# UNITED STATES PATENT AND TRADEMARK OFFICE

APPLICATION NO.	FILING DATE	FIRST NAMED INVENTOR	ATTORNEY DOCKET NO.	CONFIRMATION NO.
10/706,788	11/12/2003	John LoGuidice	BE1-0013US	7180

**Office Action Summary**

## DETAILED ACTION

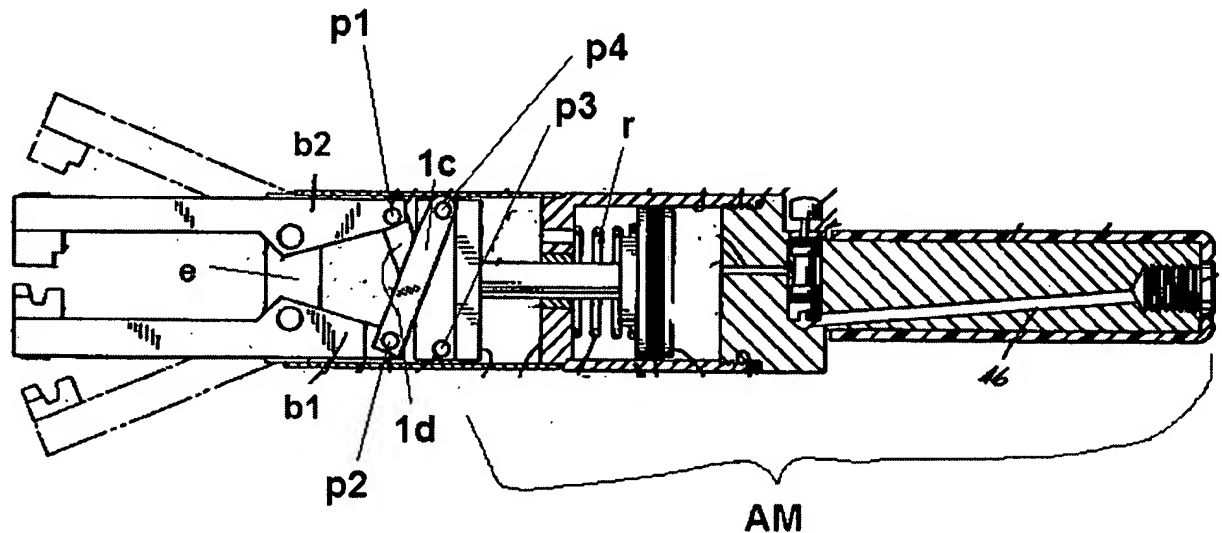
a) Regarding claim 1, Riera et al. disclose the same invention as the applicant, including a first engaging member (b1 below) configured to engage a clamp, a second engaging member (b2) configured to engage a clamp, a first interface member (1c) coupled to the first engaging member (at p2), a second interface member (1d) coupled to the second engaging member (at p1).

- d) Regarding claims 10-12, Riera et al. disclose the same invention as the applicant, including a third interface member (e) wherein the third interface member is coupled to the first engaging member (b1) and the second engaging member (b2). Note that the third engaging member can be considered to be part of either the first engaging member (b1) (as in claim 11), or the second engaging member (b2) (as in claim 12), thereby coupling the first engaging member to the second engaging member.

- e) Regarding claim 13, Riera et al. disclose the same invention as the applicant, including an actuating member (AM) configured to provide at least one of a first force and a second force.

- f) Regarding claim 16, Riera et al. disclose the same invention as the applicant, including a first force applied to the first interface member and a second force applied to the second interface member by T-bar 98 in Fig. 4.

h) Regarding claim 18, Riera et al. disclose the same invention as the applicant, including a first force and a second force in opposite directions (piston 84 pushes with a first force against spring 96, and spring 96 in turn pushes with a second force in the opposite direction)

i) Regarding claim 19, Riera et al. disclose the same invention as the applicant, including a first engaging member (b1 below) configured to engage a clamp, a second engaging member (b2) configured to engage a clamp, an actuating member (AM) configured to provide at least one of a first force and a second force (to interface members 1c and 1d at pivot points p4 and p3, respectively), a first interface member (1c) coupled to the first engaging member (at p2) and the actuating member (at p4), a second interface member (1d) coupled to the second engaging member (at p1) and the actuating member (at p3), a reset member (r) configured to disengage at least one of the first engaging member and the second engaging member from the clamp, a first support member (p2) coupled to the first engaging member and the first interface member, and a second support member (p1) coupled to the second engaging member and the second interface member.

See MPEP § 2181. Riera et al. disclose the same invention as the applicant, including a first engaging means (b1 below) configured to engage a clamp, a second engaging means (b2) configured to engage a clamp, a first interface

means (1c) coupled to the first engaging means, and a second interface means (1d) coupled to the second engaging means.

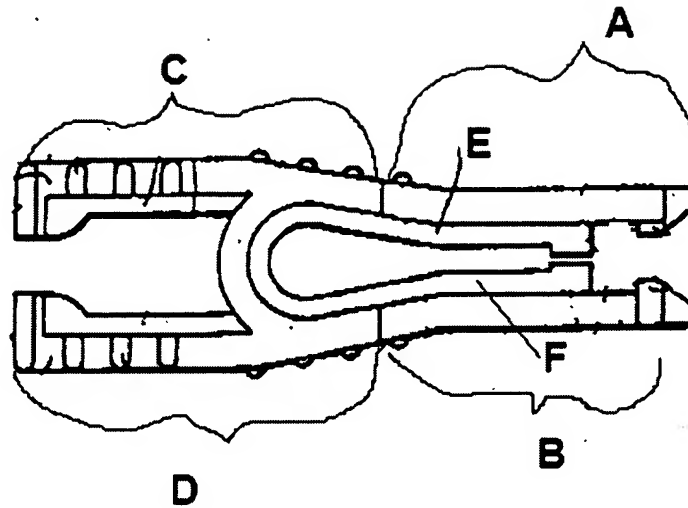
a) Regarding claim 1, Fischer discloses the same invention as the applicant, including a first engaging member (46) configured to engage a clamp, a second engaging member (17) configured to engage a clamp, a first interface member (30) coupled to the first engaging member, and a second interface member (15) coupled to the second engaging member.

b) Regarding claims 4-7, Fischer et al disclose the same invention as the applicant, including a reset member (50) configured to disengage at least one of the first engaging member and the second engaging member from the clamp (Page 1, col. 2, Ins. 19-26), wherein the reset member is coupled to at least one

(53) of the first engaging member (at 46) and the second engaging member, and wherein the reset member is coupled to at least one (at 52) of the first interface member (30) and the second interface member)
